SOLICITATION AMENDMENT MODIFICATION DE L'INVITATION

Title - Sujet CCGS PIERRE RADISSON VESSEL LIFE EX	
Solicitation No. - N° de l'invitation F7049-160074/A	Amendment No. - N° modif. 010
Client Reference No. - N° de référence du client F7049-160074	Date 2016-07-12
GETS Reference No. - N° de référence de SEAG PW-\$\$\$MD-031-25863	
File No. - N° de dossier 031md.F7049-160074	CCC No./N° CCC - FMS No./N° VME
Solicitation Closes - L'invitation prend fin at - à 02:00 PM on - le 2016-07-20	Time Zone Fuseau horaire Eastern Daylight Saving Time EDT
F.O.B. - F.A.B. Plant-Usine: <input type="checkbox"/> Destination: <input checked="" type="checkbox"/> Other-Autre: <input type="checkbox"/>	
Address Enquiries to: - Adresser toutes questions à: Bilodeau, Allen	Buyer Id - Id de l'acheteur 031md
Telephone No. - N° de téléphone (819) 420-2912 ()	FAX No. - N° de FAX () -
Destination - of Goods, Services, and Construction: Destination - des biens, services et construction:

Amendment #10 is issued to publish the following items.

3163-1 2016-07-07

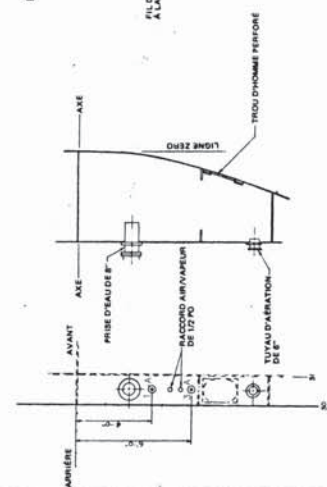
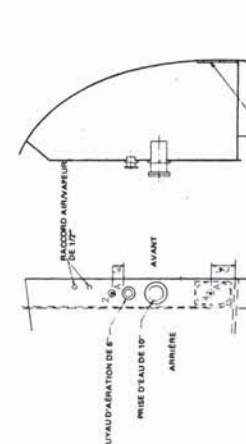
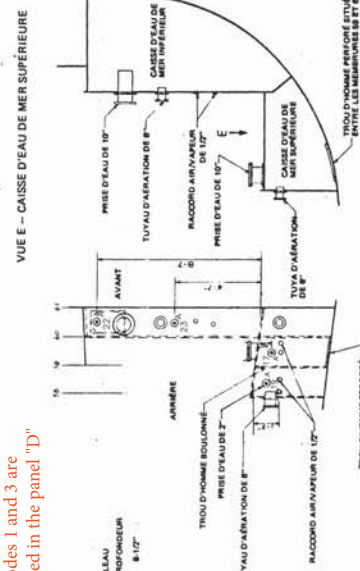
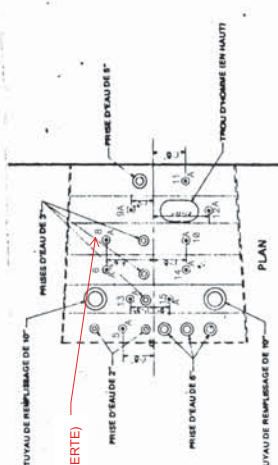
LE PANNEAU "E" N'EXISTE PLUS.
DÉMONTEZ-LE.
LES ANODES 1 ET 3 SONT
BRANCHÉES DANS LE PANNEAU "D".
Panel "E" no longer exists.
The anodes 1 and 3 are
connected in the panel "D"

NOUVEAU PANNEAU "D"
NEW CONTROL PANEL "D"

“14.3.15 By referring to drawings 3163-1 2016-07-07 and 3163-2 2016-07-07, replace 5 faulty anodes by new ones provided by the GCC. Once installed and reconnected, the contractor must check the resistance to ground of the anodes and electrical wiring that connects the anode to the control panel. The Contractor must provide a report of those readings to the IA.”

3163-2 2016-07-07

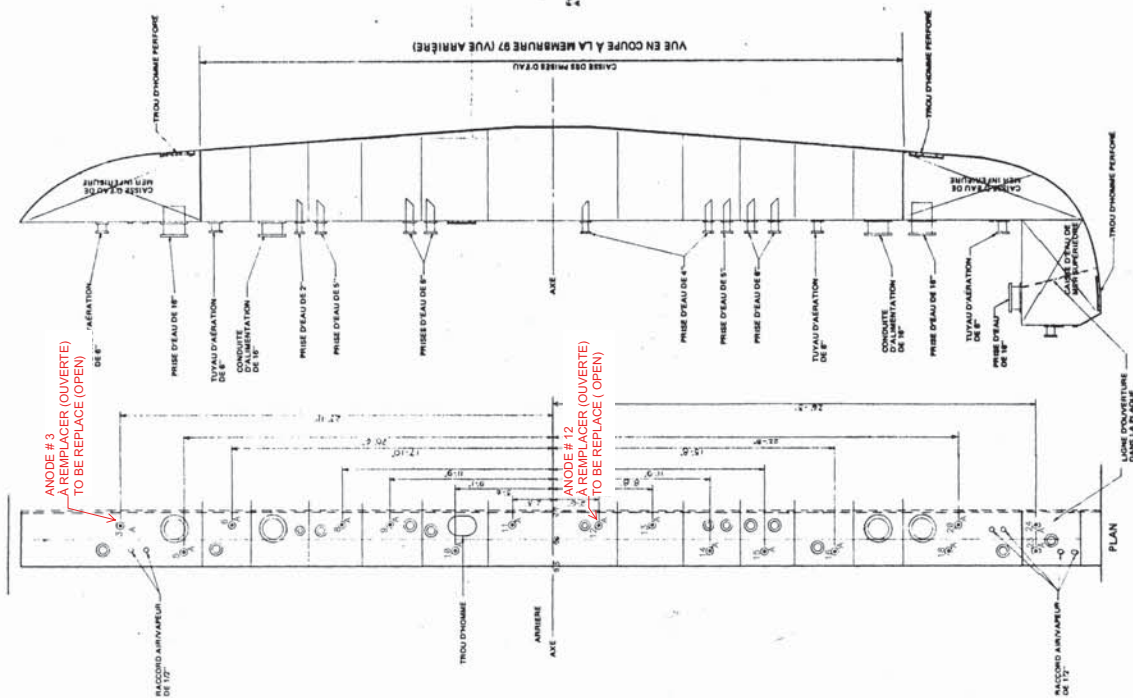
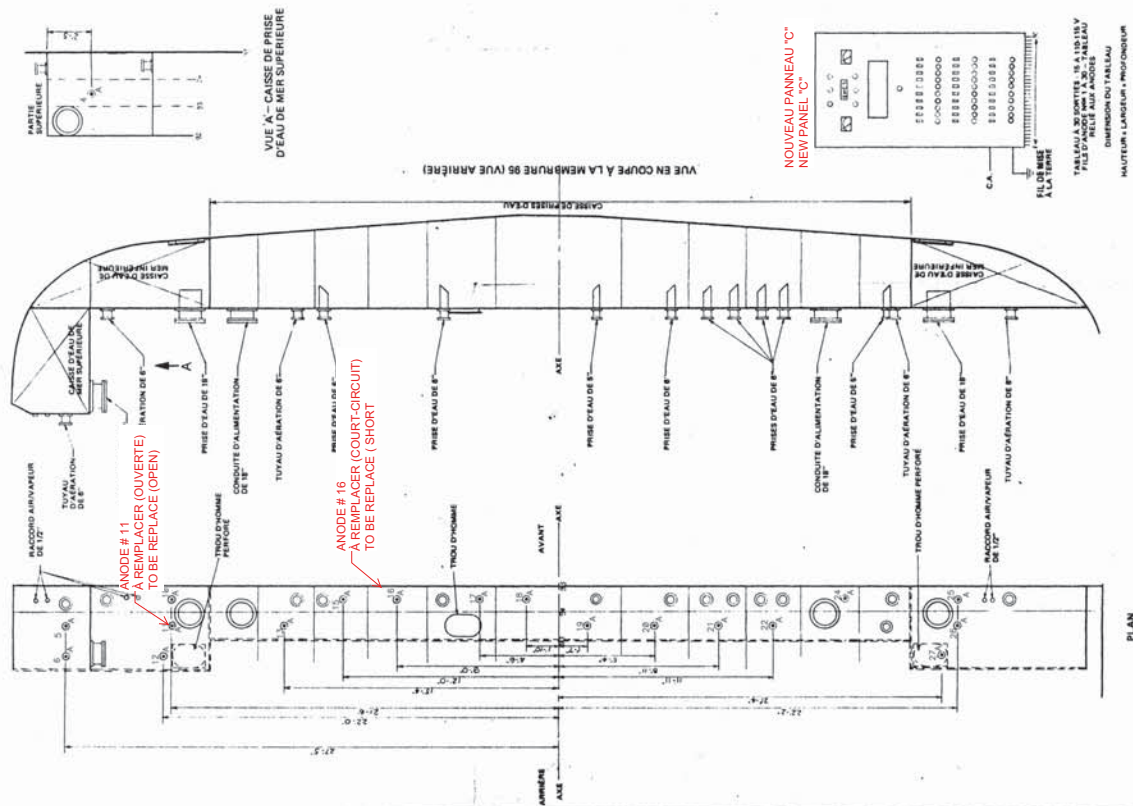
NOUVEAU PANNEAU "B"
NEW PANEL "B"

ANODE # 12
À REMPLACER (OUVERTE)
TO BE REPLACE (OPEN)

NOUVEAU PANNEAU "C"
NEW PANEL "C"
